JOHNSON DEVELOPMENT – SPEC 1 SUBDIVISION

APPLICATION NUMBER 11 DATE September 20, 2007

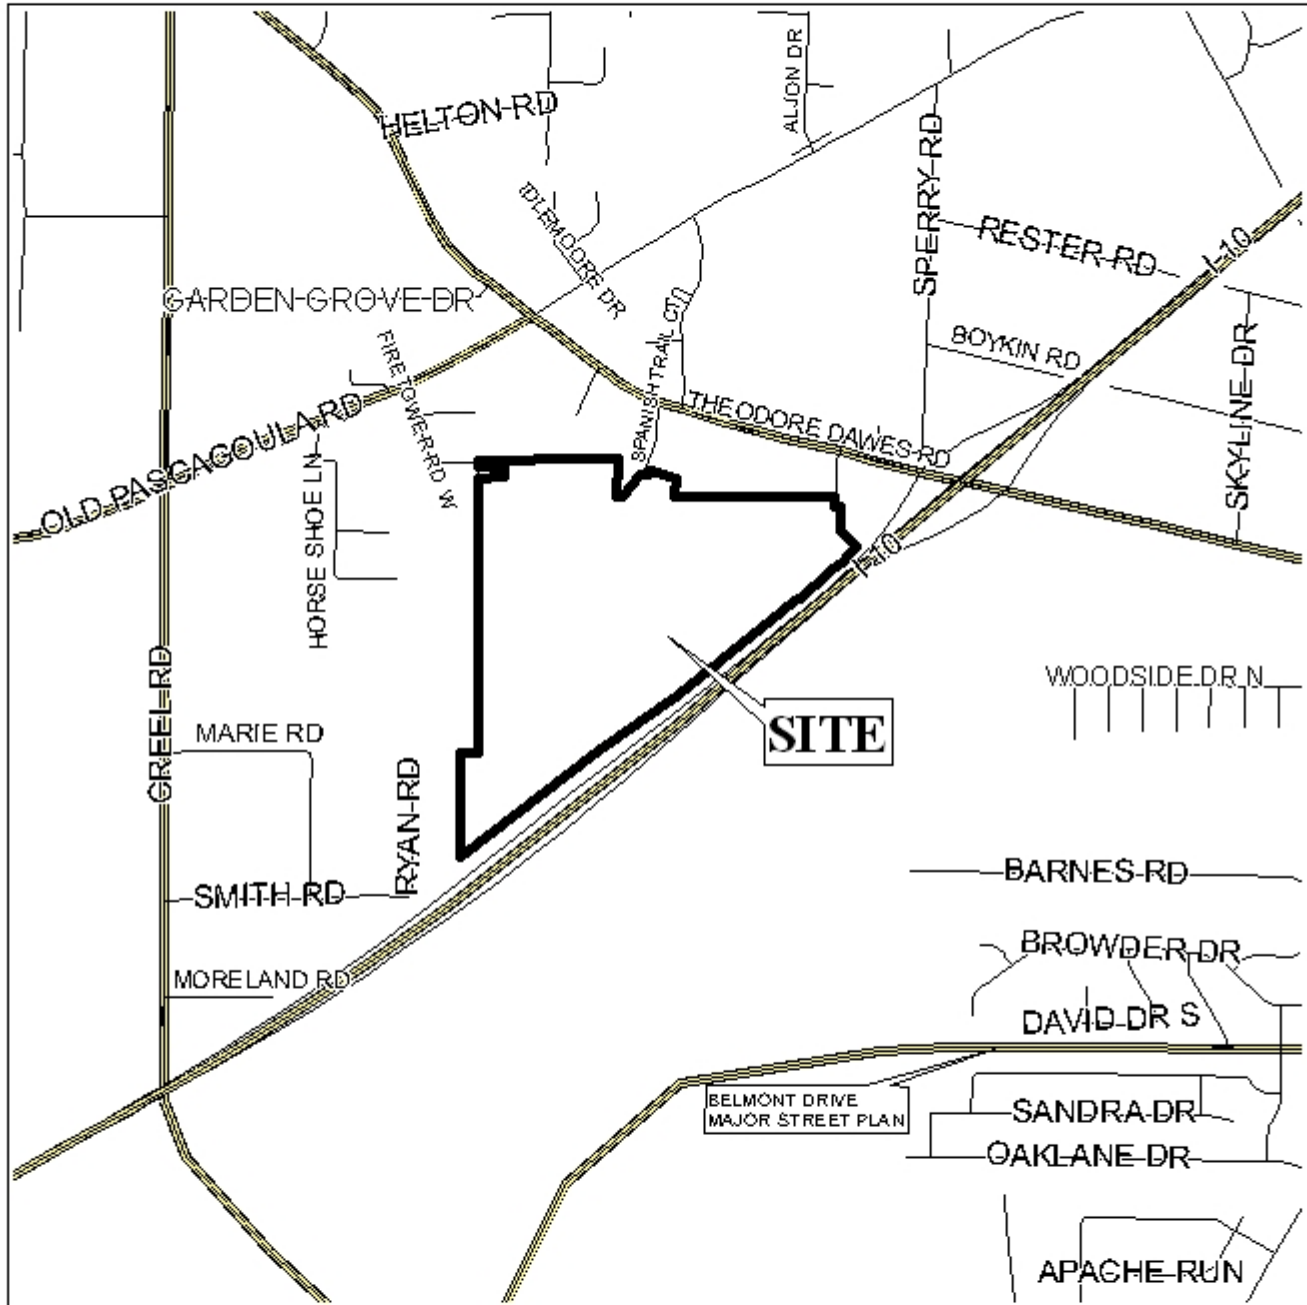
Lot 1 is proposed to have approximately 90' of frontage along the West side of Trippell Road, and 60' of frontage at the South terminus of the Trippell Road street stub. The lot will also have frontage along the North side of Interstate 10. No right-of-way dedication is required. The plat did not indicate a minimum building setback line; therefore, the plat should be revised to indicate a 25' minimum building setback line along the West and South right-of-way lines of Trippell Road and along the Interstate 10 frontage.

Lot 2 is proposed to have approximately 112' of frontage on the cul-de-sac at the South terminus of Spanish Trail Court with a 60' right-of-way. No minimum building setback line is indicated for this street frontage; therefore, the plat should be revised to indicate a 25' minimum building setback line along the Spanish Trail Court frontage. Lot 2 extends to the East terminus of Firetower Road South, a substandard road with a 45' right-of-way, and extends to the North side of Interstate 10. Again, no minimum building setback line is indicated off the terminus of Firetower Road South of Interstate 10; therefore, the plat should be revised to indicate a 25' minimum building setback line off the East terminus of Firetower Road South and along the Interstate 10 frontage.

Since both proposed lots have less than 200' of frontage on either Trippell Road or Spanish Trail Court, a note should be placed on the final plat stating that Lot 1 is limited to one curb cut to Trippell Road, and Lot 2 is limited to one curb cut to Spanish Trail Court, with the size, location, and design of all curb cuts to be approved by the Mobile County Engineering Department and conform to AASHTO standards. Since Firetower Road South is a substandard right-of-way, a note should be placed on the final plat stating that Lot 2 is denied access to Firetower Road South. Also, both lots should be denied access to Interstate 10, and a note should be placed on the final plat stating such.

Lot sizes in acres were indicated on the plat and should also be indicated on the final plat, or there should be the provision of a table on the plat depicting the same information. Also, no note is on the plat referencing buffering between commercially developed property and residentially developed property; therefore, a note should be placed on the final plat stating that any lots which are developed commercially and adjoin residentially developed property must provide a buffer, in compliance with Section V.A.7. of the Subdivision Regulations.

- 1) depiction of the 25' minimum building setback line along the West and South right-of-way lines of Trippell Road;
- 2) depiction of the 25' minimum building setback line along the Spanish Trail Court frontage;

- 3) depiction of the 25' minimum building setback line at the East terminus of Firetower Road South;
- 4) depiction of the 25' minimum building setback line along Interstate 10;

- 5) placement of a note on the final plat stating that Lot 1 is limited to one curb cut to Trippell Road, and Lot 2 is limited to one curb cut to Spanish Trail Court, with the size, location, and design of all curb cuts to be approved by the Mobile County Engineering Department and conform to AASHTO standards;

- 6) placement of a note on the final plat stating that Lot 2 is denied access to Firetower Road South;
- 7) placement of a note on the final plat stating that both lots are denied access to Interstate 10;

- 8) depiction on the final plat of the lot sizes in acreage, or provision of a table on the plat depicting the same information;
- 9) placement of a note on the Final Plat stating that any lots which are developed commercially and adjoin residentially developed property must provide a buffer, in compliance with Section V.A.7. of the Subdivision Regulations; and
